LOCA at 11th and Belmont The Goat Blocks

Design Review Submittal (LU# 14-125908 DZM AD) (DAR# 13-224797) (Pre-Application# EA-203772)

PRESENTED BY: KILLIAN PACIFIC
OWNER: BELMONT INVESTMENT, LLC
ARCHITECT: ANKROM MOISAN ARCHITECTS
06.30.2014

Design Updates & Comment Responses

Market Walk Section Looking South - Before 1/8" = 1'

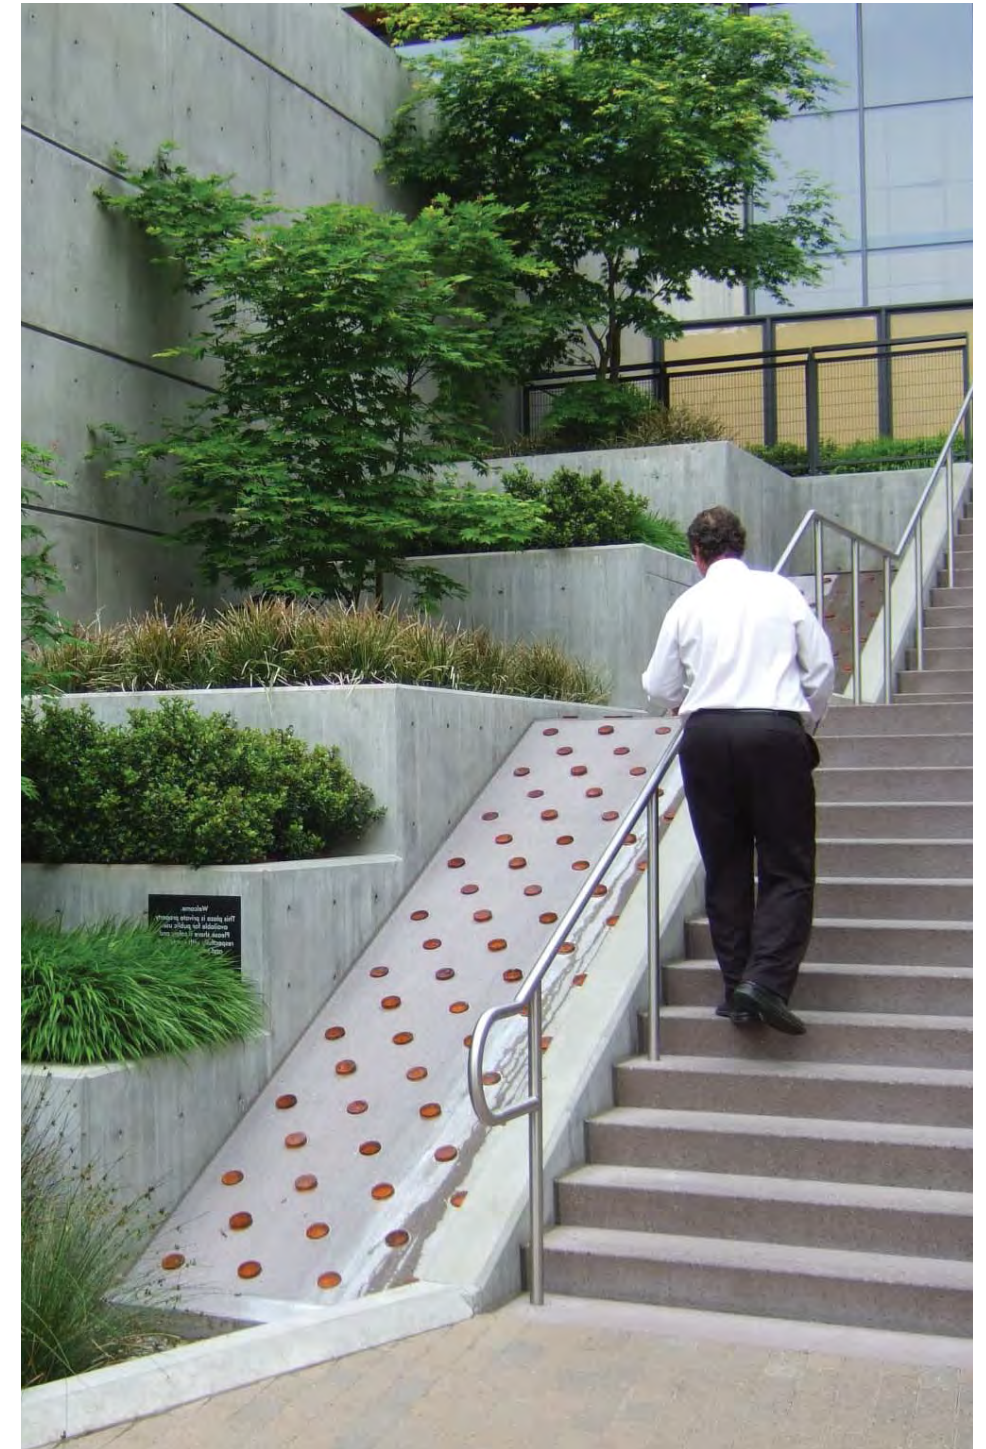
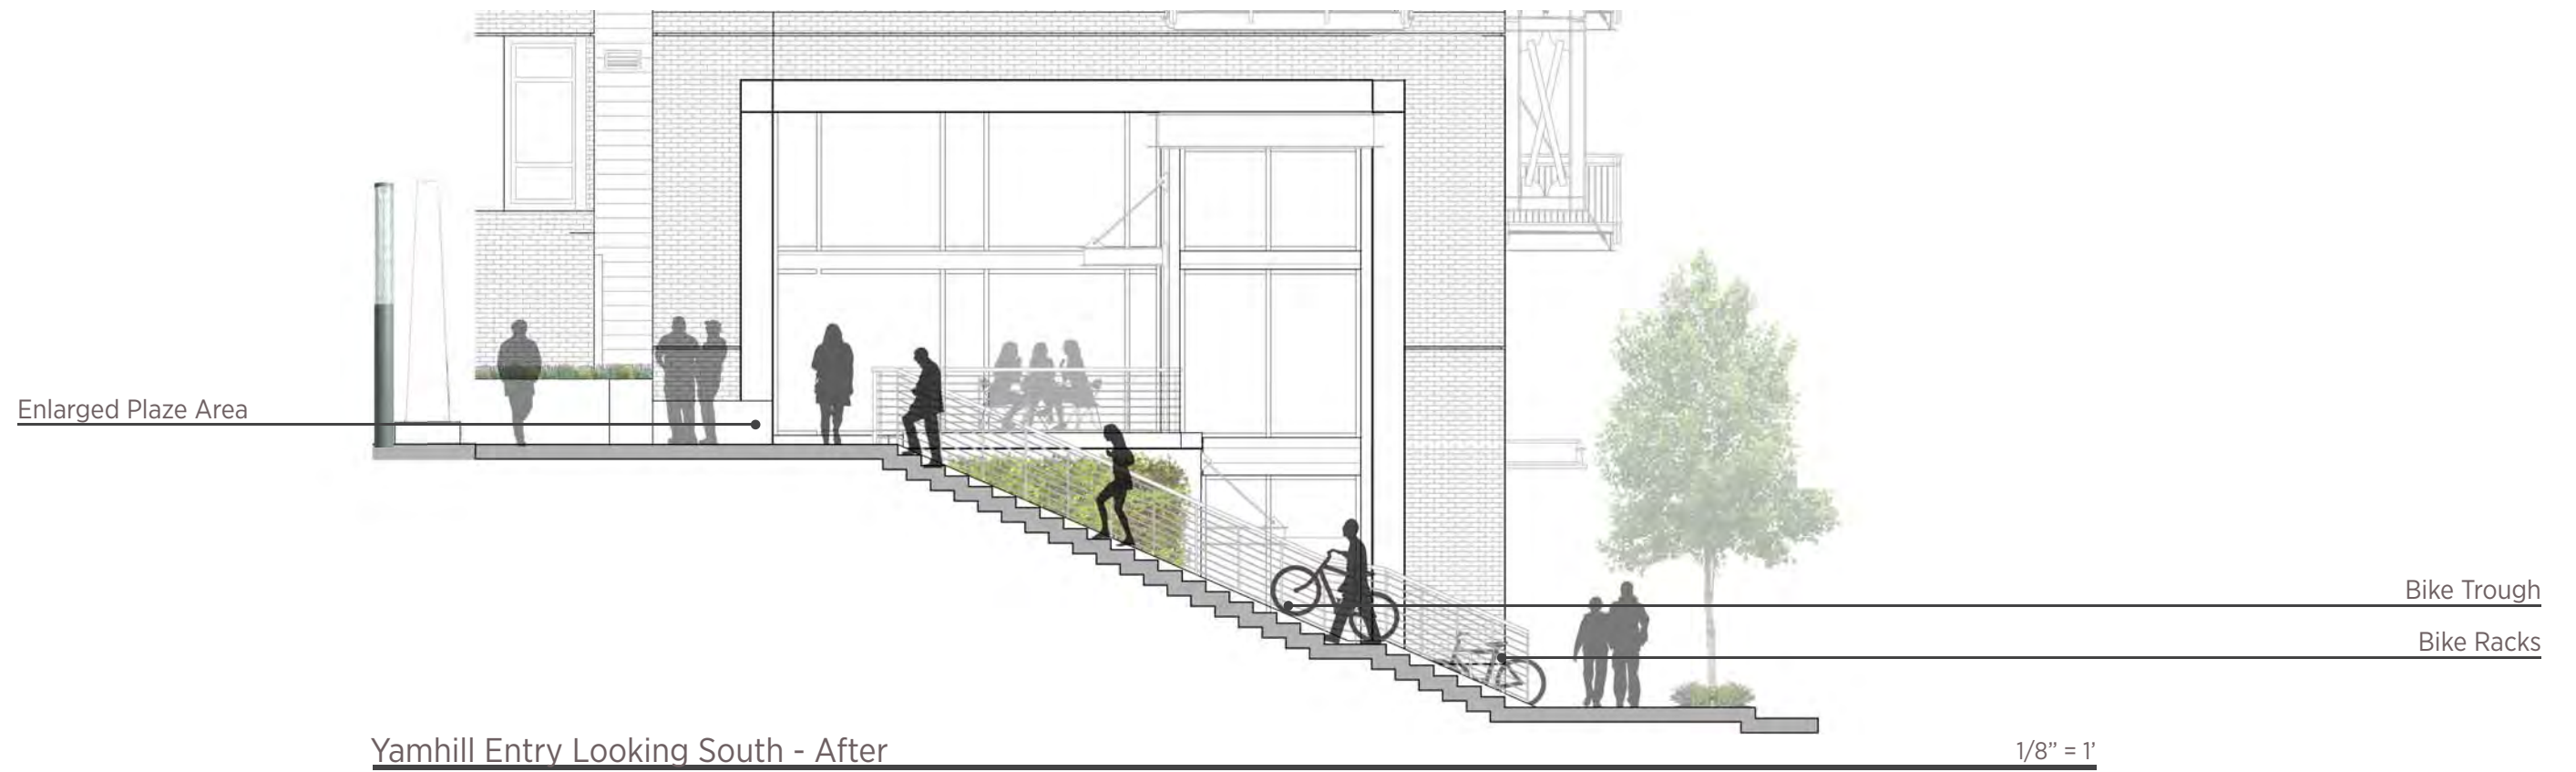
remove cylinder light

Yamhill Entry Elevation - Before

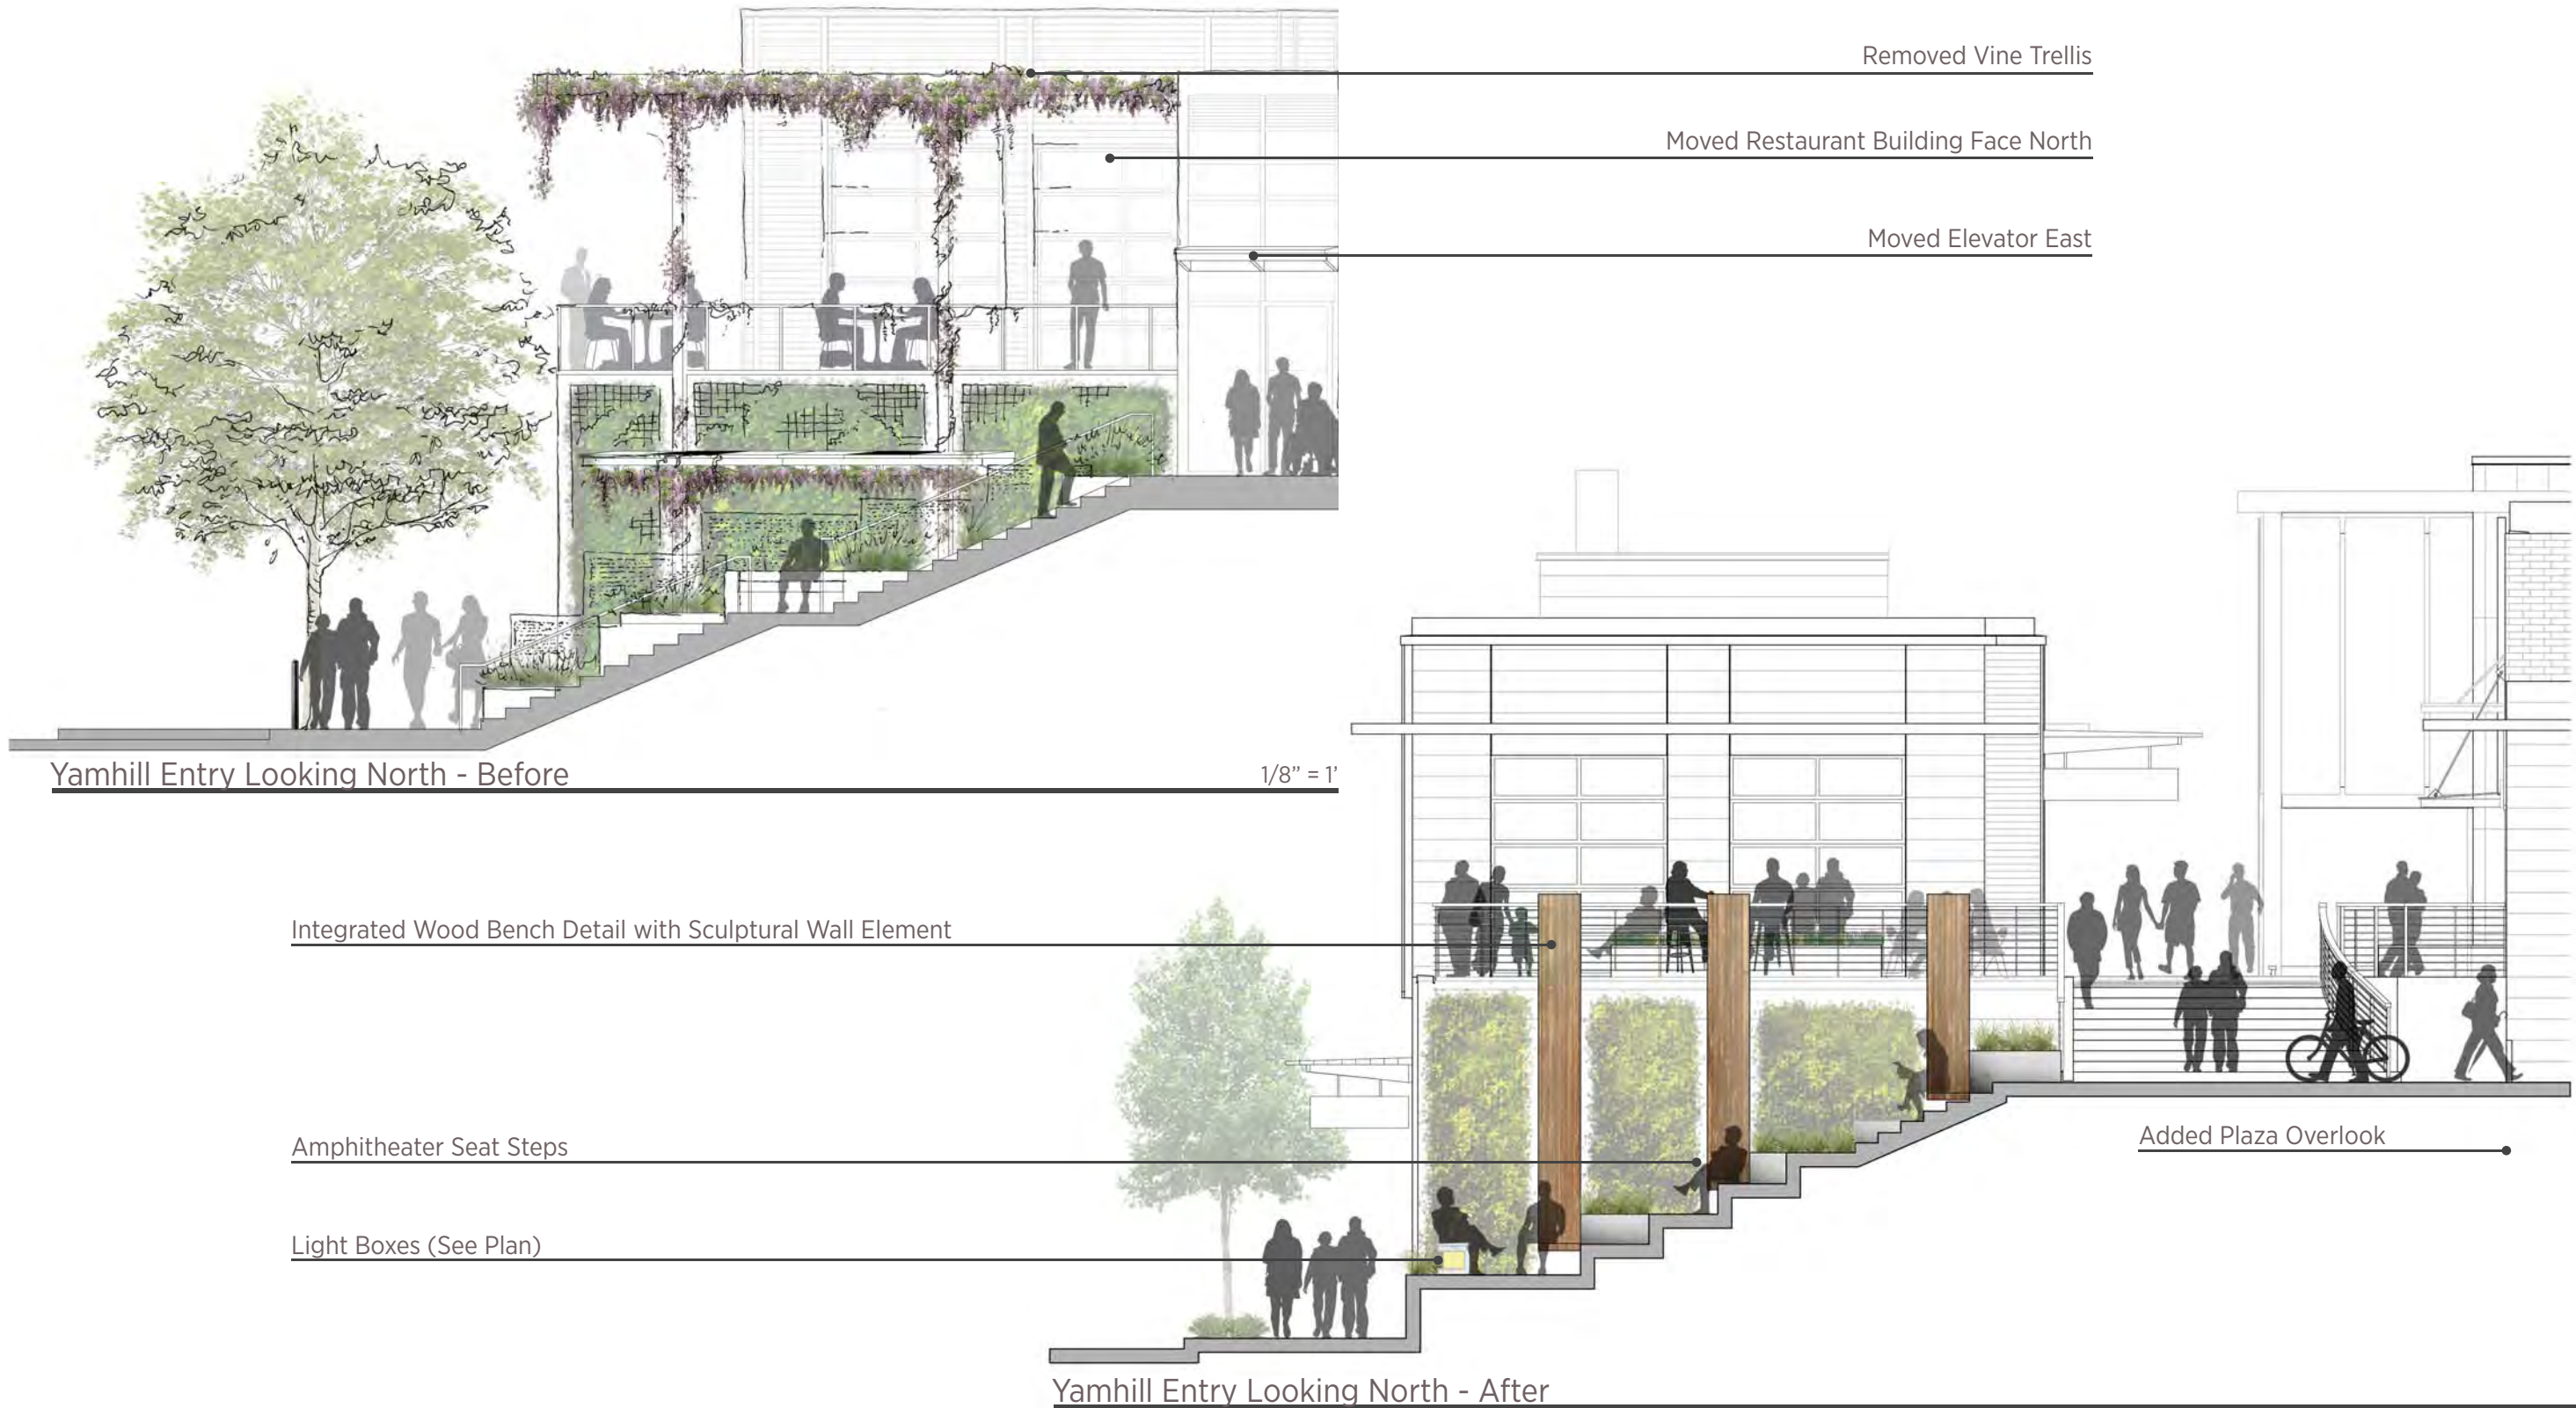
Provide Common Thread

Added Plaza Overlook

Simplified Flow Thru Planters
